IEEE 802.3cg

10BASE-T1S Autoneg and Link Status Indication

November 7th, 2018

Figure 147-4 PCS Transmit state diagram (part a)

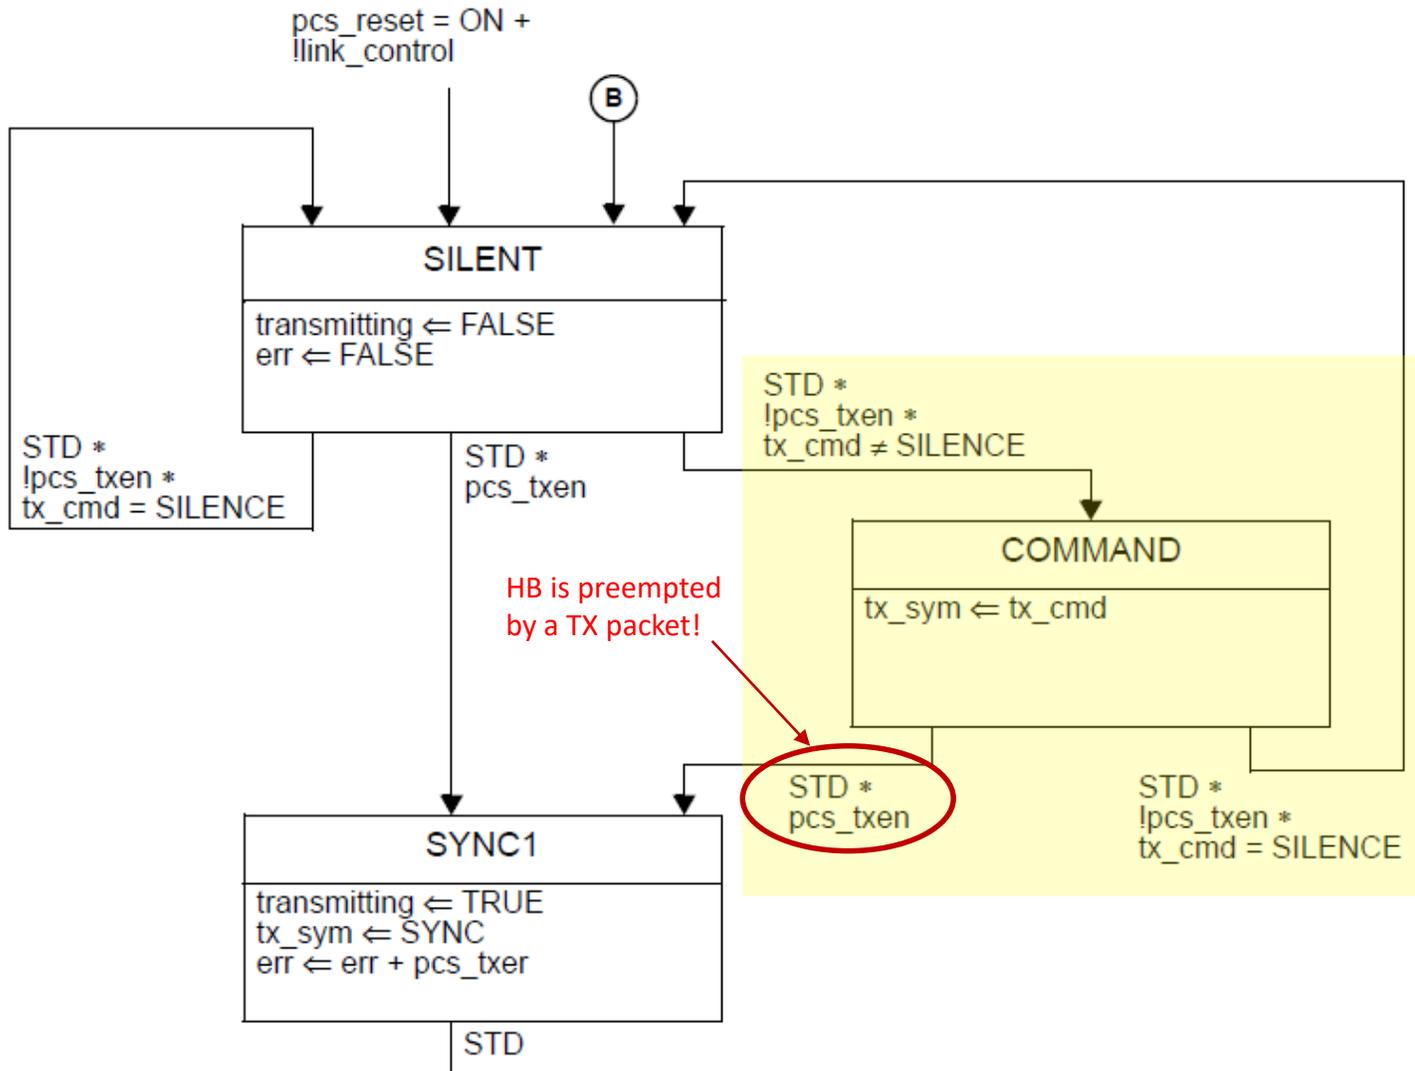
Not interfering with TX from MII: re-use of PCS TX COMMAND state to send HB on the line

HEARTBEAT is a repeated 'T' (01101) 5B symbol. Such symbol is already used as ESD but it can be re-used for this purpose (no ambiguities)

It is transmitted by PCS TX, using the already available `tx_cmd` variable.

The `tx_cmd` variable is used by PLCA RS to convey BEACON and COMMIT commands to the PHY. PLCA takes precedence over the HB.

Figure 147-2—10BASE-T1S PHY interfaces

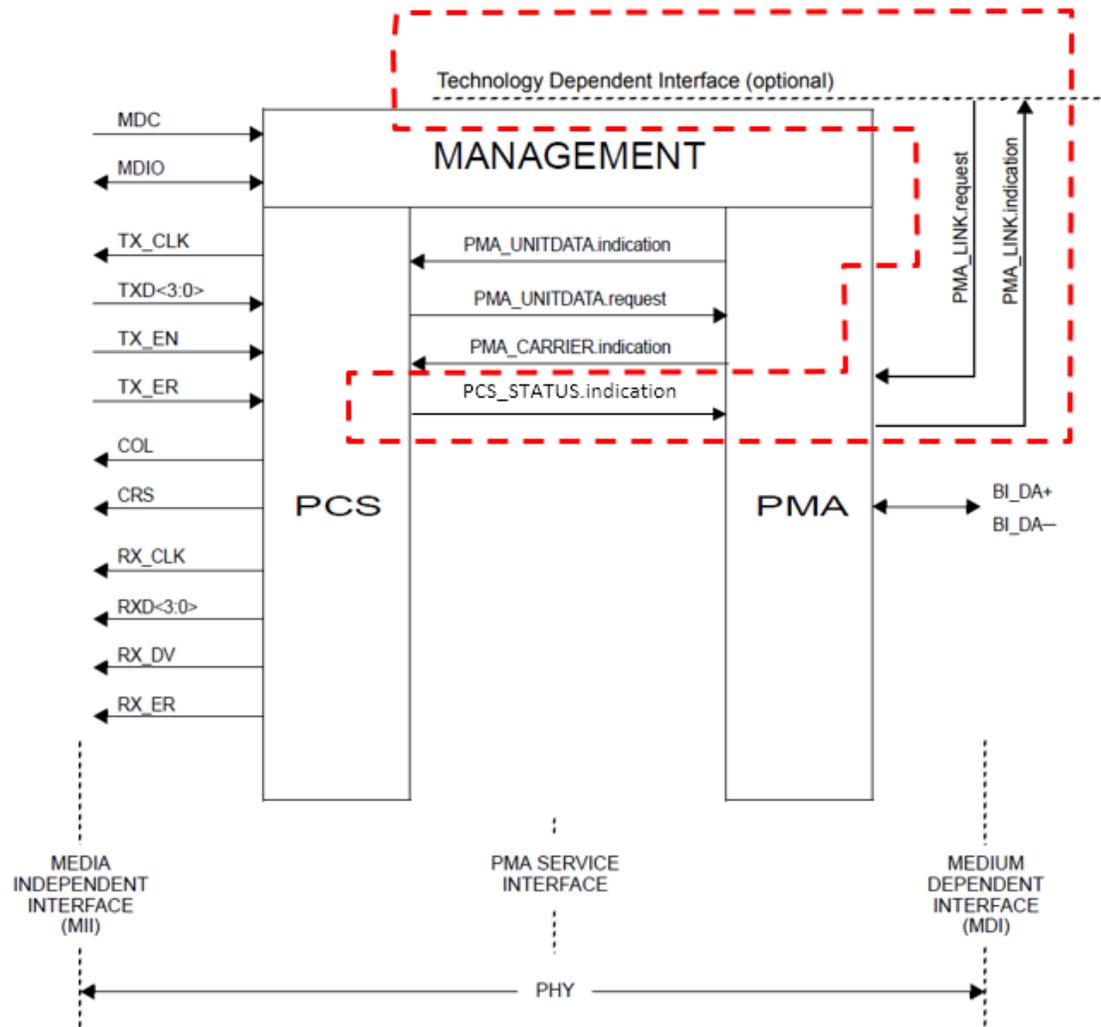
Change Figure 147-2 as shown (red dashed boxes indicate changes – these are not intended for the final figure):

- Change Figure 147-2
 - Add PMA_LINK.indication
 - Add PMA_LINK.request
 - Add PCS_STATUS.indication
 - Add Technology Dependent Interface

Figure 147-3—PCS reference diagram

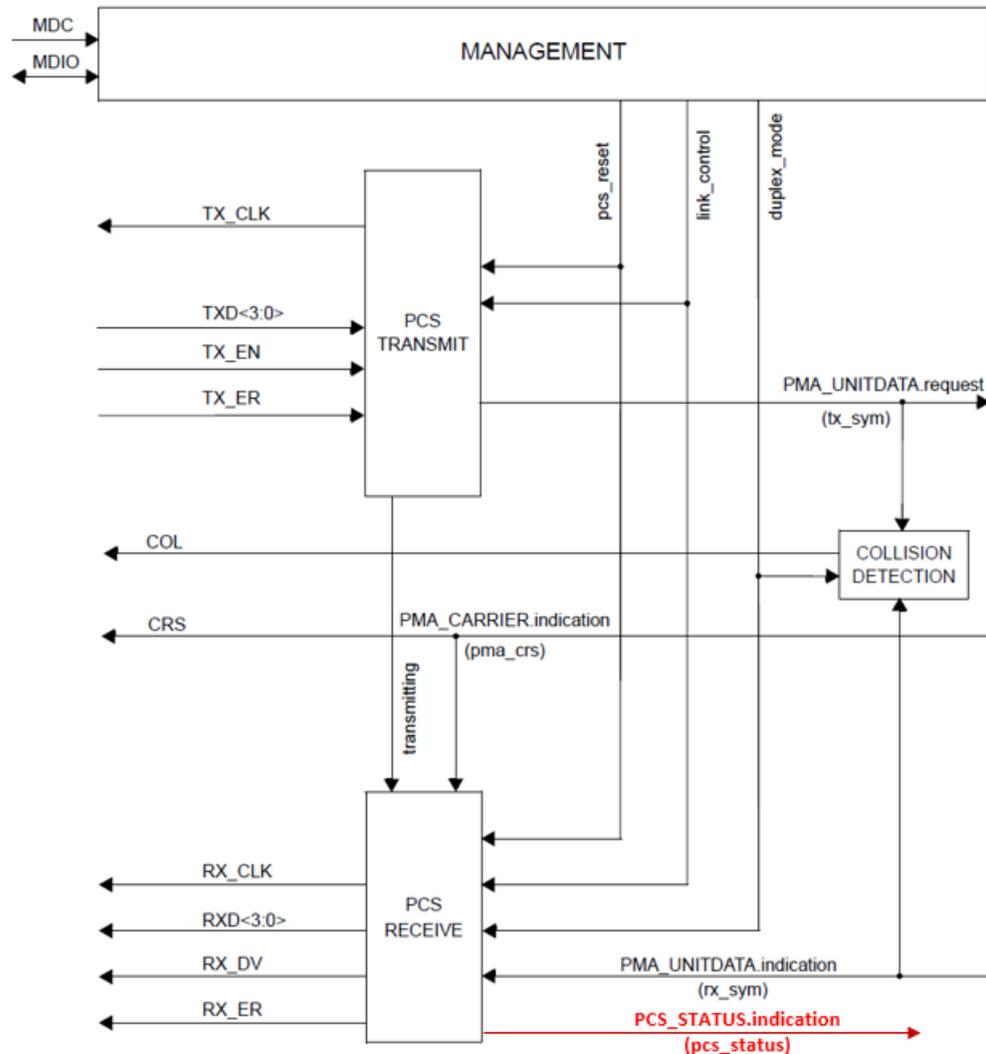
Change Figure 147-3 to add PCS_STATUS.indication primitive as shown (changes in red):

- Change Figure 147-3
 - Add PCS_STATUS.indication primitive as in the left picture (red)

Figure 147-10—PMA functional block diagram

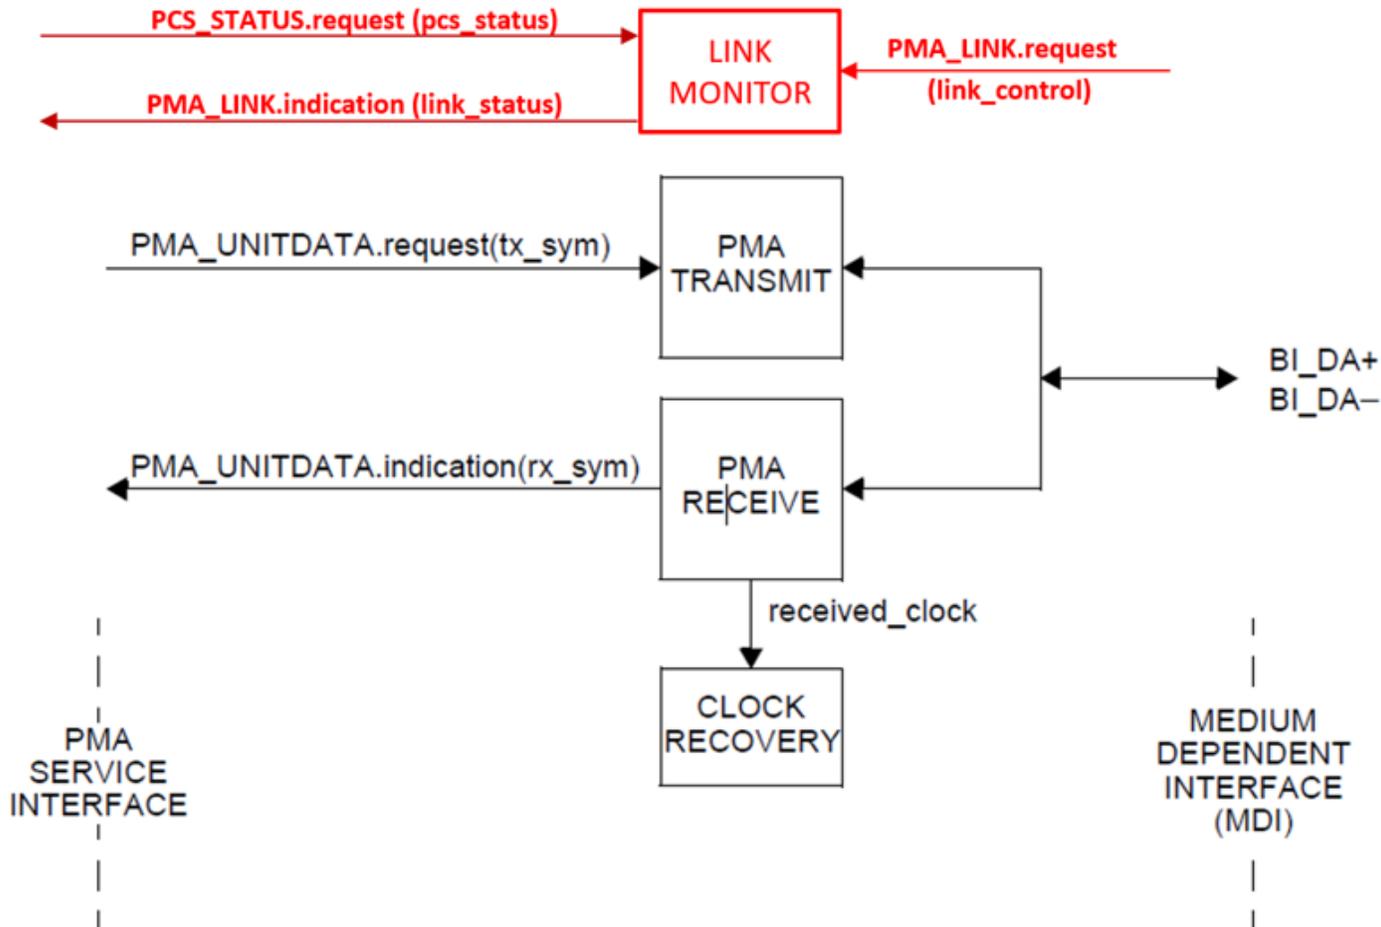
Change Figure 147-10 to add LINK MONITOR and primitives as shown (changes in red):

- Change Figure 147-10
 - Add Link Monitor block and related primitives as depicted in red

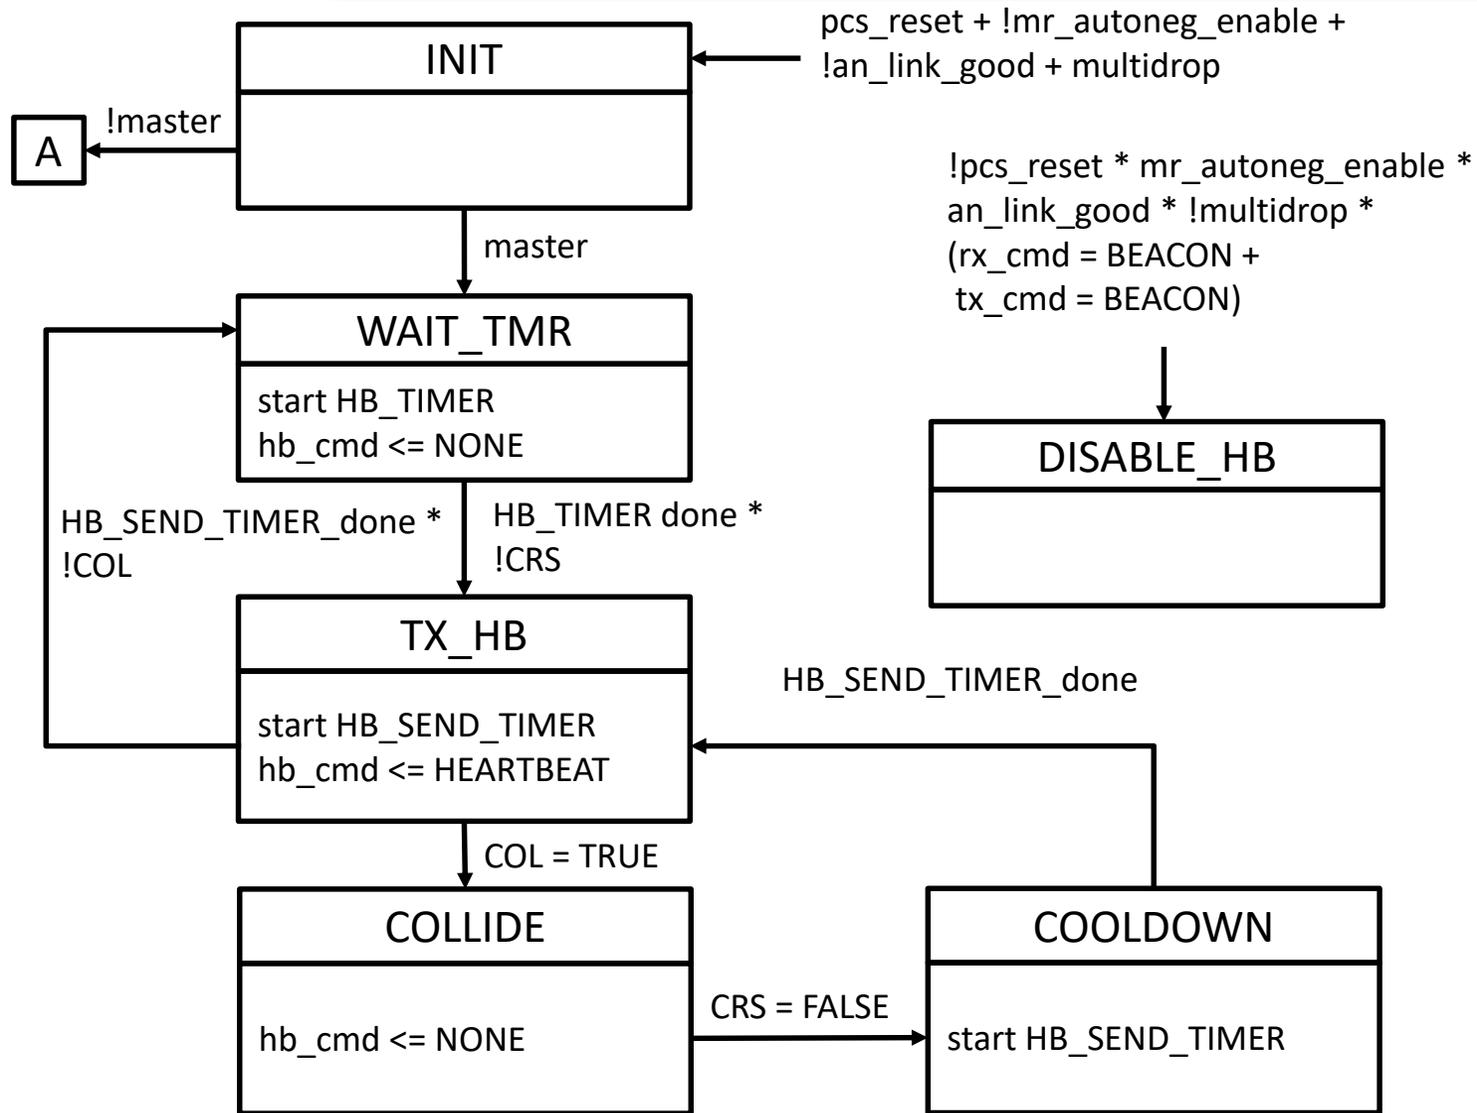
In clause 147.3.2.2, change description of tx_cmd as follows:

5B symbol to be transmitted when the PCS Transmit function is in ~~SILENT~~ COMMAND state. The tx_cmd variable is assigned according to ~~the~~ PLCA RS signaling over MII interface, as defined in 22.2.2.4, 148.4.3.1.1, and 148.4.3.1.2. in conjunction with value of the hb_cmd variable, defined in 147.3.8.2.

The following mapping shall be used:

- tx_cmd <= 'N' when a BEACON request is asserted,
- tx_cmd <= 'J' when a COMMIT request is asserted,
- tx_cmd <= 'T' when hb_cmd variable is set to HEARTBEAT and none of the previous requests is asserted,
- tx_cmd <= 'I' otherwise.

HB Transmit State Diagram 1/2

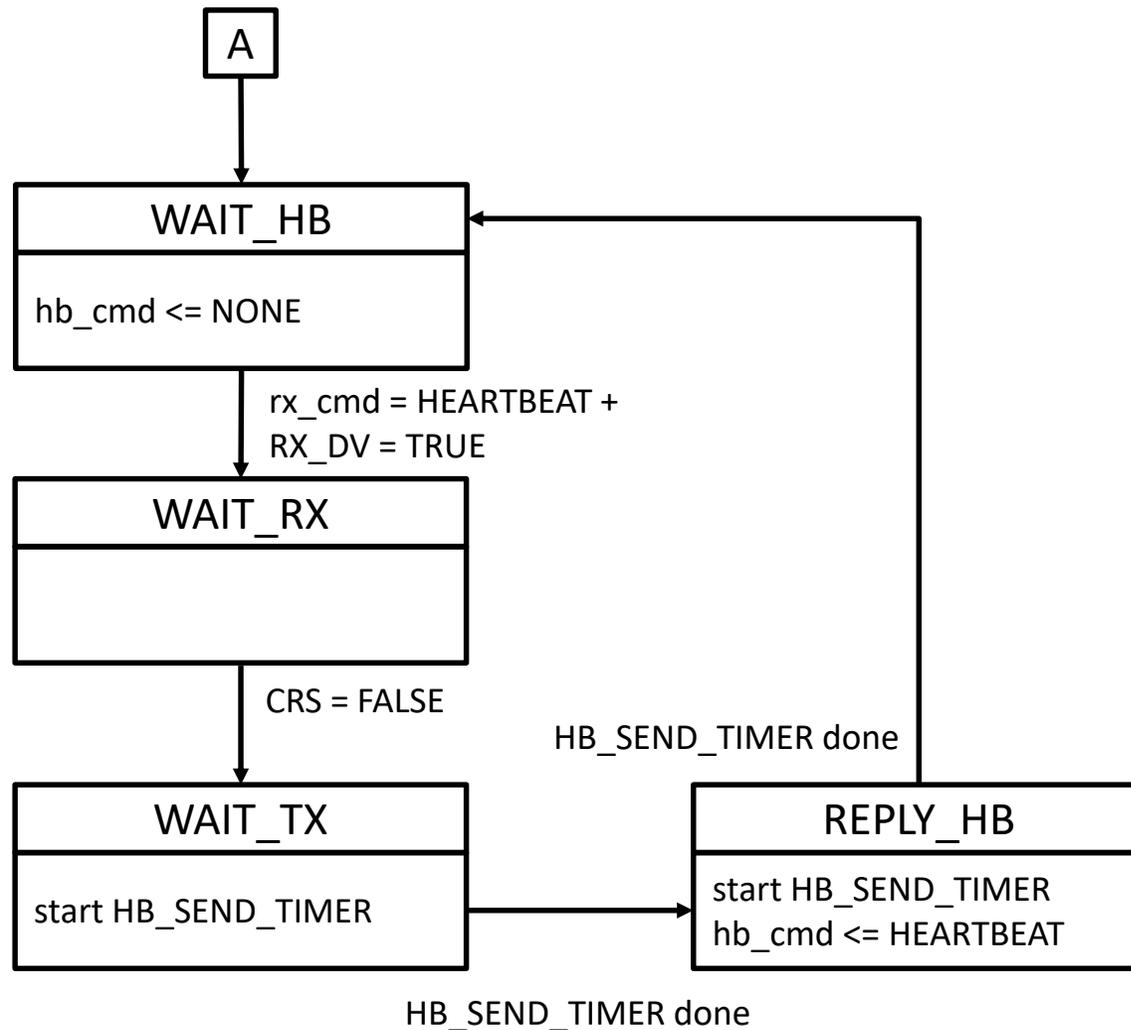
- $HB_TIMER = 50\text{ ms}$
- $HB_SEND_TIMER = \text{duration of HB on the line} = 20\text{ bit-times}$
- $mr_autoneg_enable = \text{Auto-Negotiation supported and enabled}$
- $an_link_good = \text{Auto-Negotiation complete}$
- $multidrop = \text{Multidrop mode (register 1.2299.10)}$
- $master = \text{TRUE}$ when master role negotiated using method in 98.2.1.5 and Table 98-4
- $rx_cmd = \text{enumerated value set to 'BEACON'}$ when a BEACON indication is generated as specified in 147.3.7.1. Set to 'COMMIT' when a COMMIT indication is generated as specified in 147.3.7.2. Set to 'HEARTBEAT' when a HB is detected on the line. Set to 'NONE' otherwise.

HB Transmit State Diagram 2/2

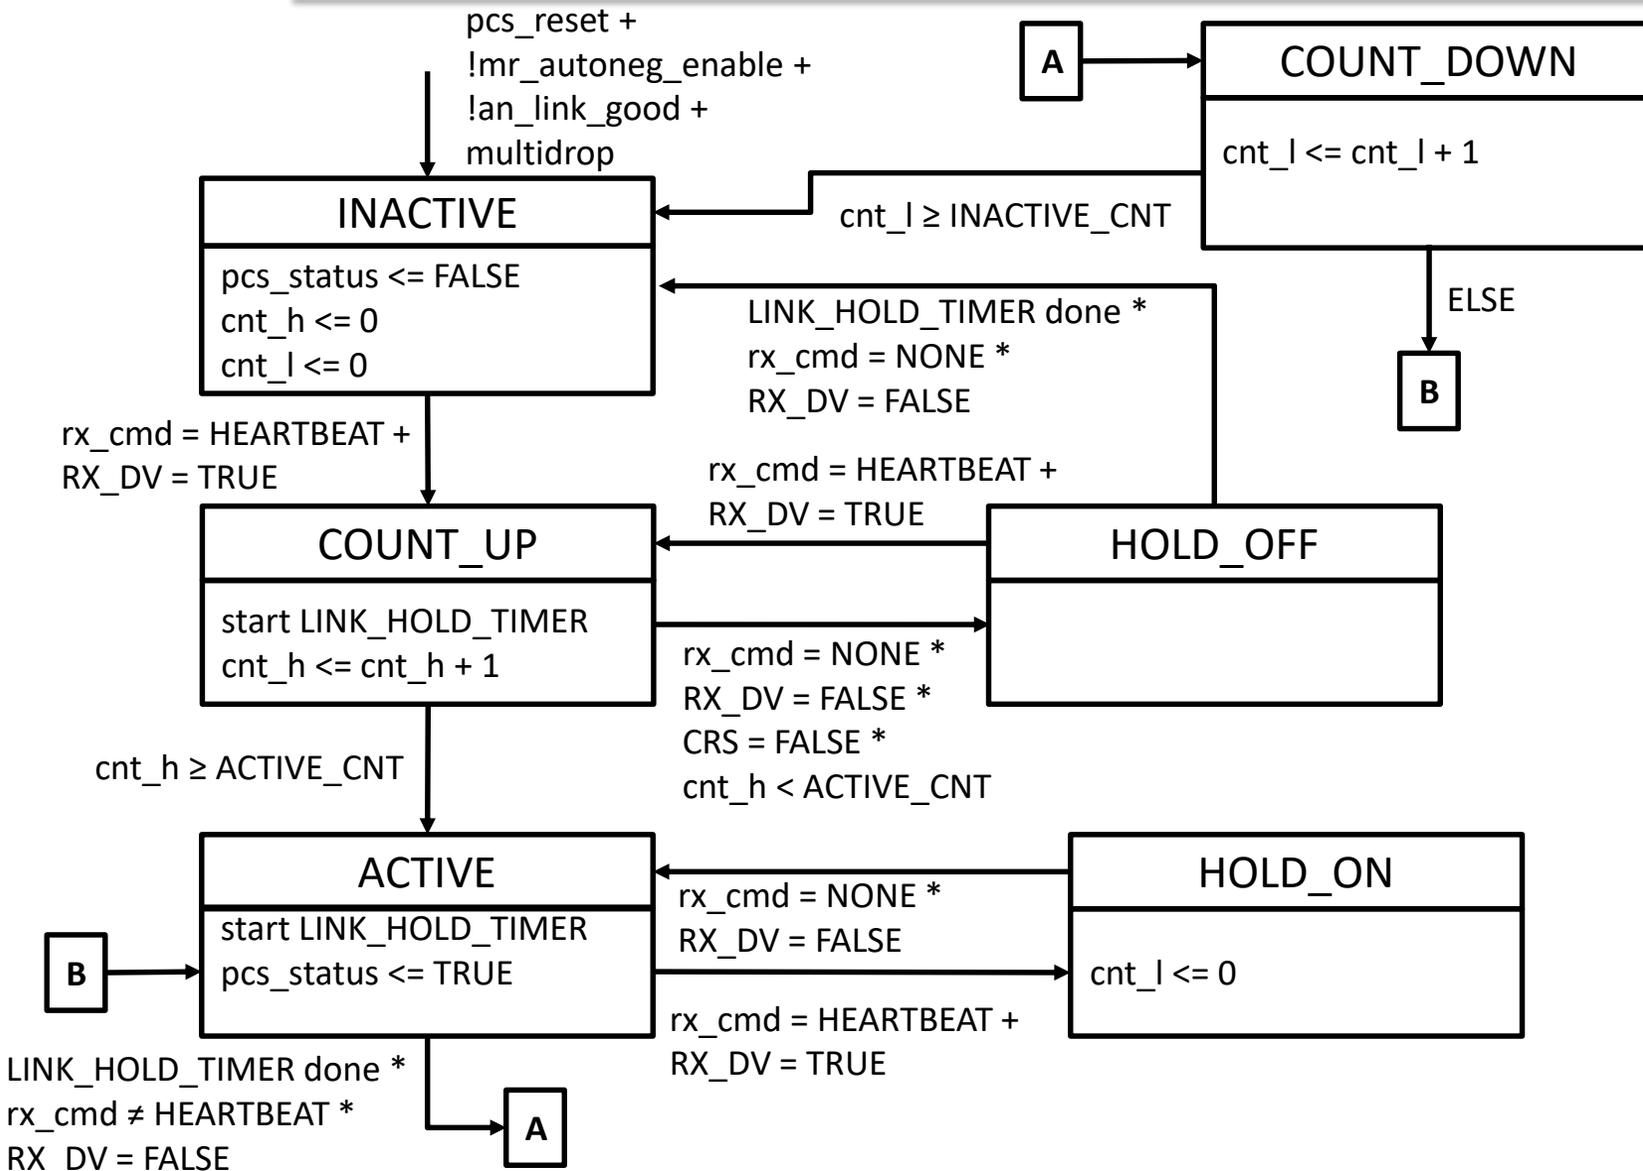
- **HB_SEND_TIMER** = duration of HB on the line = 20 bit-times
- **mr_autoneg_enable** = Auto-Negotiation supported and enabled
- **an_link_good** = Auto-Negotiation complete
- **multidrop** = Multidrop mode (register 1.2299.10)
- **hb_cmd** = enumerated value. Values: HEARTBEAT, NONE.

HB Receive State Diagram

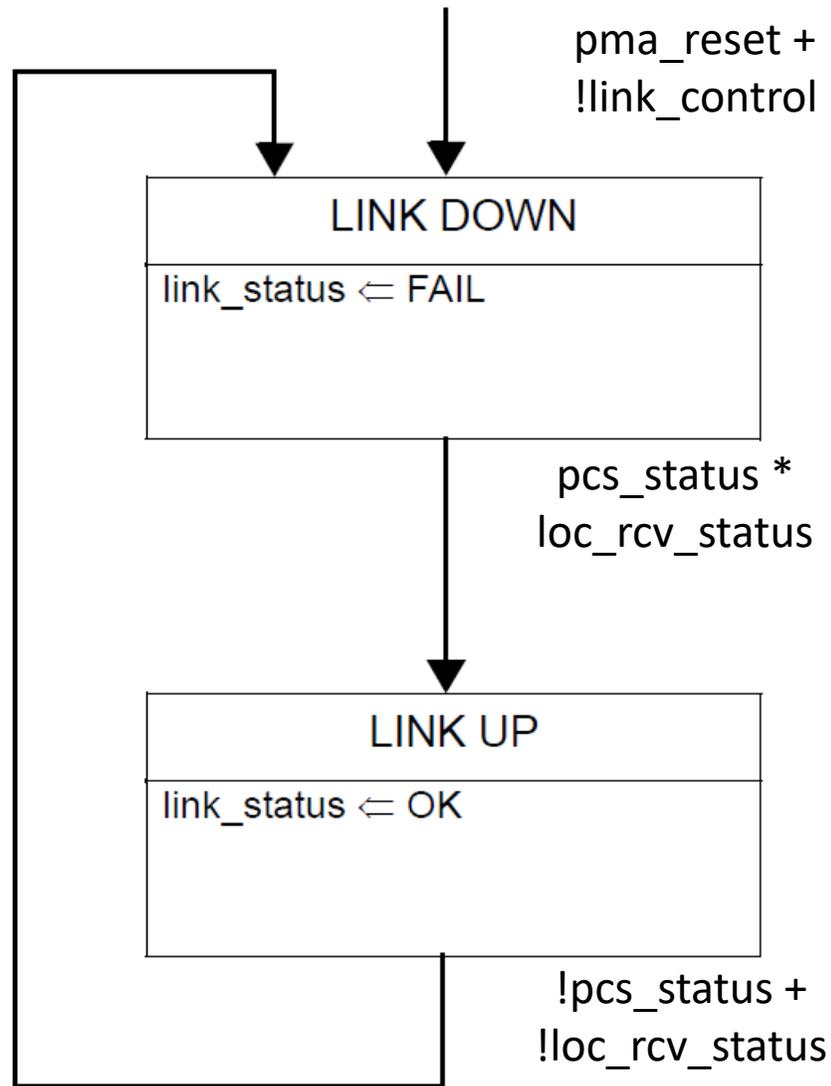
- cnt_l = counter of HB when pcs_status is TRUE
- cnt_h = counter of HB when pcs_status is FALSE
- ACTIVE_CNT = number of HB required to signal pcs_status = TRUE
Value: **2**
- INACTIVE_CNT = number of HB required to signal pcs_status = FALSE
Value: **5**
- LINK_HOLD_TIMER: time after which the count of HB is reset
Value: **50 ms**
